<b>ORDINARY MEETING</b> <b>20 JANUARY 2010</b>	<b>14</b>
---	-----------

REQUEST FOR NEGOTIATED DECISION FOR MATERIAL CHANGE OF USE (MULTIPLE DWELLINGS- 4 UNITS) - 11 HIBISCUS LANE HOLLOWAYS BEACH - DIVISION 8

<u>PROPOSAL:</u>	REQUEST FOR NEGOTIATED DECISION FOR MULTIPLE DWELLINGS (4 UNITS)
<u>APPLICANT:</u>	A L NUNN C/- PETER ROBINSON PLANNING PO BOX 4751 CAIRNS QLD 4870
<u>LOCATION OF SITE:</u>	11 HIBISCUS LANE HOLLOWAYS BEACH
<u>PROPERTY:</u>	LOT 26 ON RP709285
<u>PLANNING DISTRICT:</u>	BARRON SMITHFIELD
<u>PLANNING AREA:</u>	RESIDENTIAL 3
<u>PLANNING SCHEME:</u>	CAIRNSPLAN 2009
<u>REFERRAL AGENCIES:</u>	NIL
<u>NUMBER OF SUBMITTERS:</u>	N/A
<u>STATUTORY ASSESSMENT DEADLINE:</u>	N/A
<u>APPLICATION DATE:</u>	06/11/2009
<u>DIVISION:</u>	8
<u>APPENDIX:</u>	<ol style="list-style-type: none"> <li>1. APPROVED PLAN(S) &amp; DOCUMENT(S)</li> <li>2. DEVELOPER CONTRIBUTION CALCULATIONS</li> <li>3. SUPPORTING INFORMATION</li> </ol>

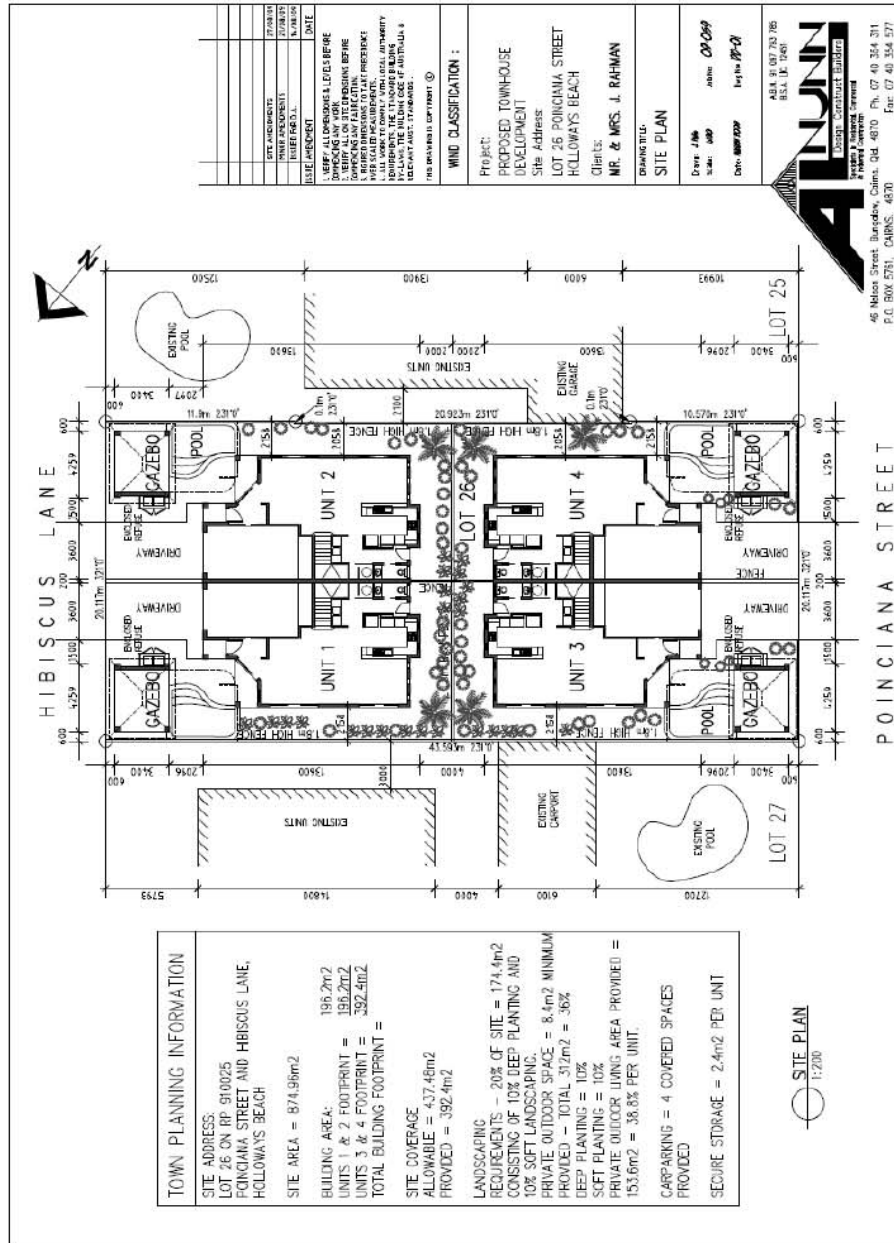
It is requested that this condition be deleted. The applicant contends that there is no existing underground electricity infrastructure in either street and direct connections from the existing overhead supply are available.

The applicants request is not supported. The condition is not requiring that the power pole be placed underground. The condition requires that the connection between the existing pole and the site be placed underground. This is a standard requirement for new development and ensures that electricity supply to the site is safe and unexpected interruptions to the power supply due to storms, cyclones, or branches falling onto powerlines are minimised.

SITE PLAN  
1:200

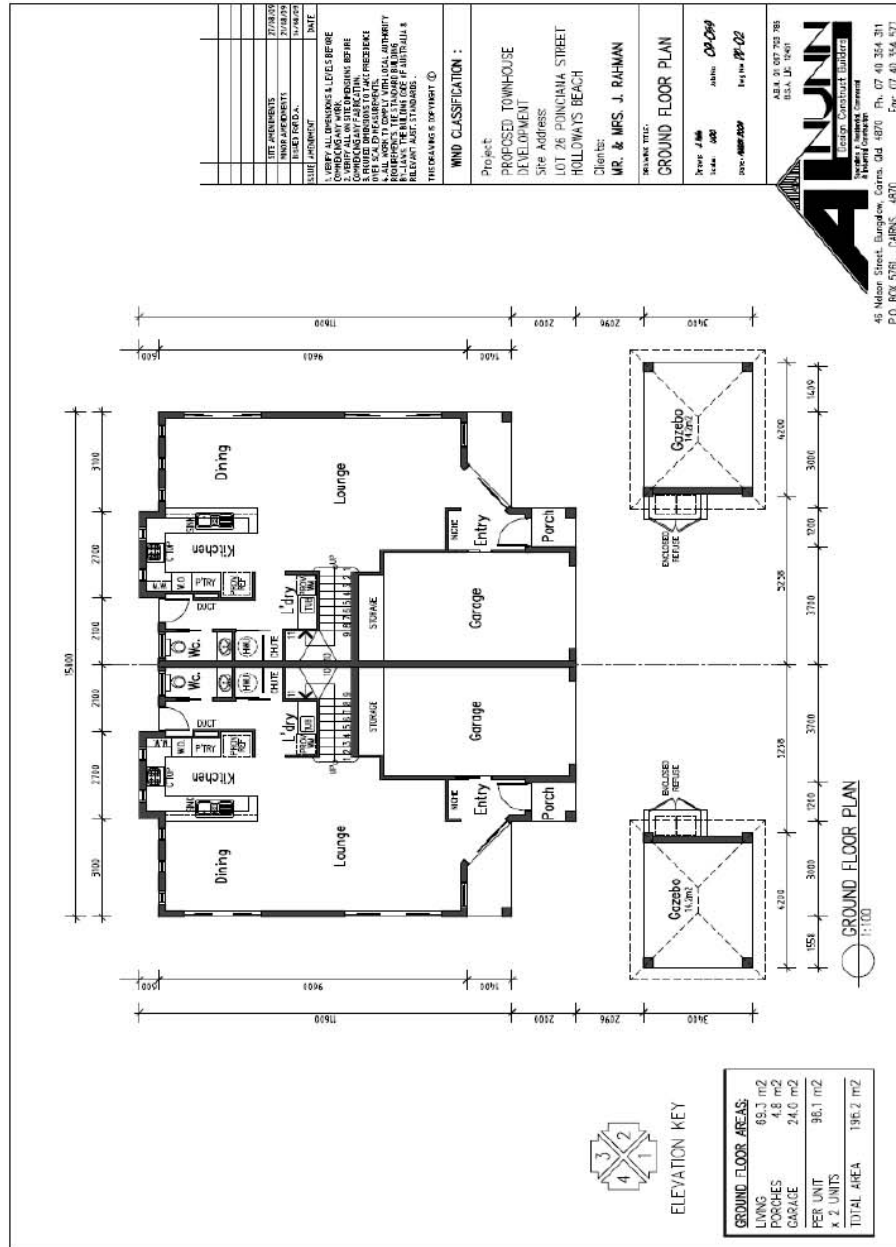
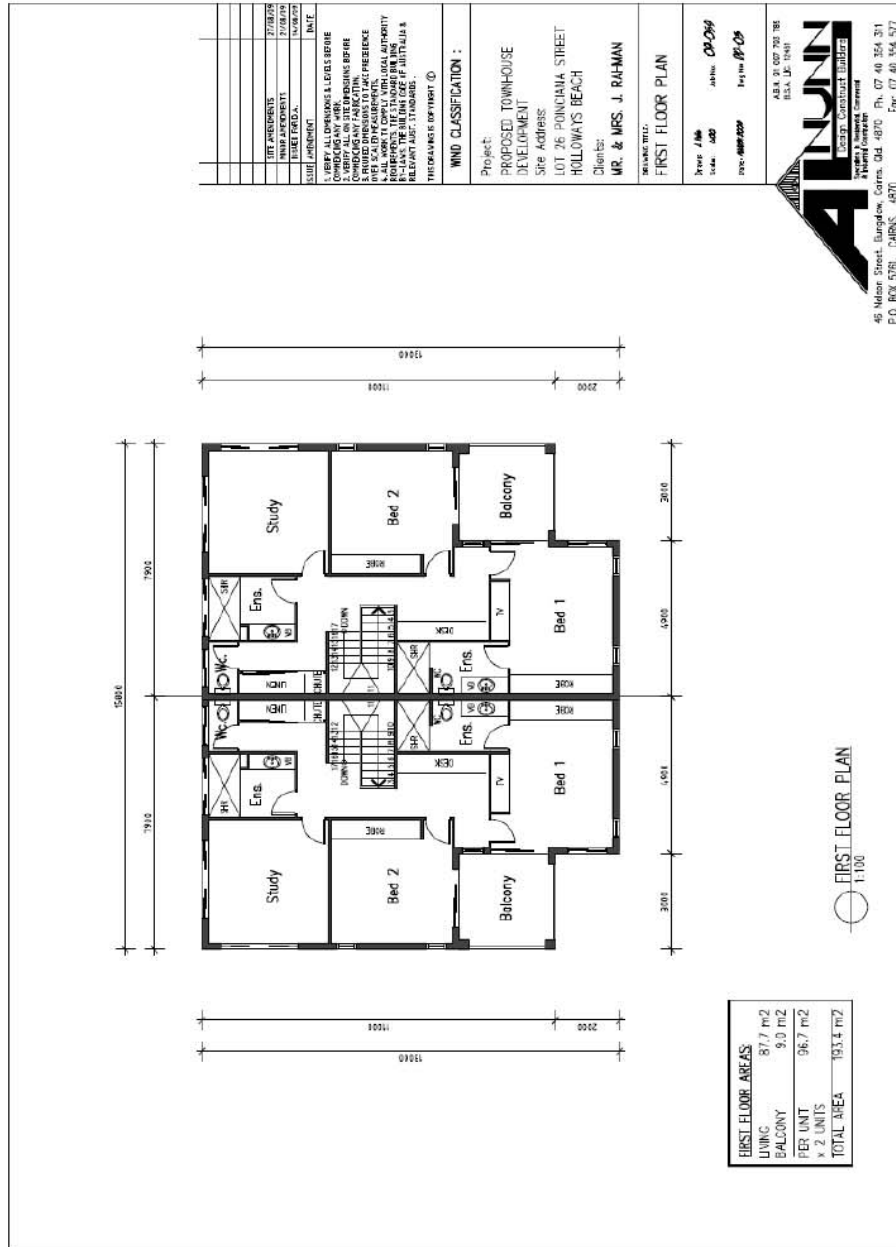
It is requested that Condition 3c be amended to read:

*Reduce the total combined width of the crossovers on each site frontage to a maximum of 6 metres.*

The applicant contends that there is no logical justification for this in terms of the relevant codes, aesthetics, and traffic or safety issues. The applicant explains that if the allotment were to be occupied by a house with a standard double garage the crossover width would ordinarily be 6 metres. The applicant also argues that halving the width of the driveway as it crosses the footpath is inconvenient and potentially dangerous. Drivers reversing out of the garage not only have to concentrate on other vehicles and pedestrians, they have to perform a rather precise S shaped manoeuvre between the boundary of the property and the carriageway. In summary, that applicant contends that no useful purpose is served by the requirement to reduce the crossover width to 3.6 metres and a number of adverse consequences result.

The applicant requests that Condition 3e be deleted. The applicant considers that there is no useful purpose served by the additional landscaping and the implementation of this condition considerably reduces the utility and amenity of both the pool and the gazebo while creating maintenance and other adverse consequences.

The applicants request is not supported.

Contrary to the applicant's submission, the requirement for a 3.6 metre wide crossover is a requirement of Acceptable Measure 13.2 of the Multiple Dwelling (Small Scale Development) Code. The related Performance Criteria states:

The proposed six (6) metre wide cross over is not consistent with the Performance Criteria or the Acceptable Measure. The condition was included to ensure that the hardstand area at the front of the site was reduced. It is also noted that there are no footpaths on either street.

Also contrary to the applicant's suggestion that a single dwelling on the site would ordinarily have a six (6) metre wide crossover, the FNQROC Development Manual Standard Drawing S1015 specifies a maximum crossover width of three (3) metres for residential development (which includes dual occupancy and houses). Six (6) metre wide vehicle crossovers are not consistent with accepted development practices.

Adequate space for manoeuvring of vehicles should be provided onsite. Development should not rely on the road verge to achieve safe and convenient access to the site. It is also argued that pedestrian safety benefits from smaller driveway widths which give priority to pedestrian traffic rather than vehicles.

The amendment to design condition provides an opportunity for the applicant to modify the design to improve onsite vehicle manoeuvring arrangements while also reducing the width of the driveway and crossover.

The applicants request is not supported.

The proposal is inconsistent with Acceptable Measure A3.1 which requires buildings to be setback a minimum of 6 metres from any road frontage or in established areas within 20% of the average setback of adjoining development. While the units are setback over six meters from the road frontage, proposed gazebos for each unit are positioned on the road frontage of both Hibiscus Lane and Poinciana Street. The related Performance Criteria states:

Acceptable Measure A7.3 also requires that buildings are setback a minimum of one meter from the side and rear boundary. Once again while the main unit building complies, the proposed gazebos are located 0.6 meters from the side boundary, with eaves almost on the boundary. The related Performance Criteria requires that:

Condition 3e is included to ensure compliance with these Performance Criteria. The applicant's suggestion that a 1.8 meter high fence on the side property boundaries will provide an alternative acceptable solution is not supported.
